# CITY OF ALBUQUERQUE

**RE: 4800 Northern Trails NW  
Grading and Drainage Plan  
Engineer's Stamp Date: 01/21/22  
Hydrology File: F11D017B**

## DRAINAGE AND TRANSPORTATION INFORMATION SHEET (REV 6/2018)

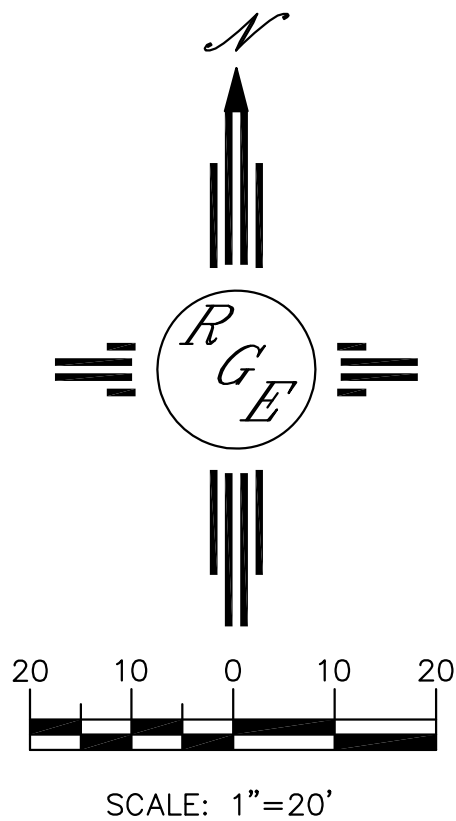
Based upon the information provided in your submittal received 01/21/2022, the Grading and Drainage Plan is approved for Building Permit and Grading Permit. Since this site is relatively flat, a pad certification is not needed for this project. Please attach a copy of this approved plan in the construction sets for Building Permit processing along with a copy of this letter.

1. Engineer's Certification, per the DPM Part 6-14 (F): Engineer's Certification Checklist For Non-Subdivision is required.
